# Access Compliance Report

## Public Rights-of-Way

### (Curb Ramps)

Intersection ID: 49389	Main Street: AUBRAC_LN	Cross Street: SHORTHORN_ST	Location: NE
ADA ID: 22FD22E4B0CC	Ramp Type: Perp	Initial Pass/Fail: Fail	Overall Compliance: No
Severity Score: 8.75			
Codes/Mitigation Info/Possible Solution		Field Measurements/Component Compliance

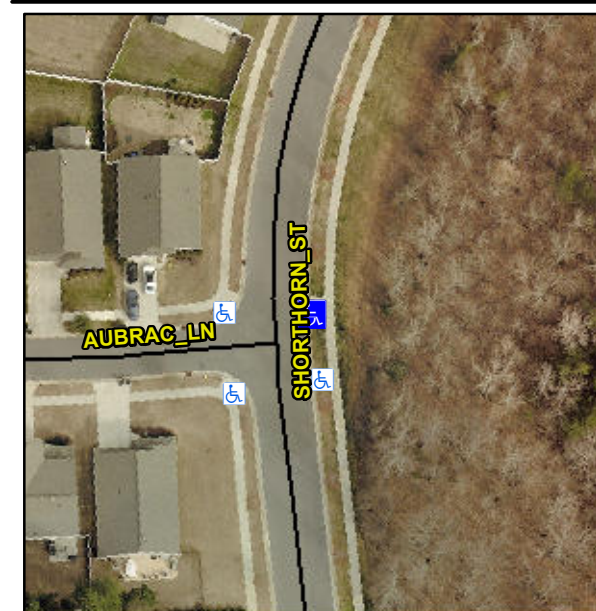
**Not Found, R304.5.1**

Compliance	Description	Data	Compliance	Description	Data
N/A	Ramp Length (in)	95.0	Yes	Ramp Slope (%)	7.5
No	Ramp Width (in)	47.0	Yes	Ramp XSlope (%)	1.2
N/A	Flare Type LT	N/A	N/A	Flare Type RT	N/A
N/A	Flare Slope LT (%)	N/A	N/A	Flare Slope RT (%)	N/A
N/A	Flare Traversable LT?	N/A	N/A	Flare Traversable RT?	N/A
N/A	Landing Length (in)	N/A	N/A	DWS Provided?	N/A
N/A	Landing Width (in)	N/A	N/A	DWS Contrast?	N/A
N/A	Landing Slope (%)	N/A	N/A	DWS Length (in)	N/A
N/A	Landing X Slope (%)	N/A	N/A	DWS Full Width?	N/A
N/A	Landing Curb? (Y/N)	N/A	N/A	DWS Offset (in)	N/A
N/A	Shared Landing?	N/A			
N/A	Gutter Ponding?	N/A	N/A	Gutter Slope (%)	N/A
N/A	Gutter Lip Ht (in)	0.5	N/A	Gutter X Slope (%)	N/A
N/A	Painted X Walk1?	No	N/A	Painted X Walk2?	N/A
	X Walk 1 Direction	To W		X Walk 2 Direction	N/A
N/A	X Walk 1 Width (in)	N/A	N/A	X Walk 2 Width (in)	N/A
	X Walk 1 Slope (%)	3.2		X Walk 2 Slope (%)	N/A
	X Walk 1 X Slope (%)	1.3		X Walk 2 X Slope (%)	N/A

N/A	Ramp inside XWalk1?	N/A	N/A	Ramp inside XWalk2?	N/A
	Road Slope (%)	N/A	N/A	Clear Space?	N/A
	Road X Slope (%)	N/A	N/A	Clear Space to XWalk (in)	N/A
N/A	Any Obstructions?	N/A	N/A	Storm Grate/Utility Hazard?	N/A
	Obstruction Type			Storm Grate/Utility Type	
		N/A			N/A
			Yes	Surface Condition? (G/P)	Good

**Remove & Replace Entire Ramp.**
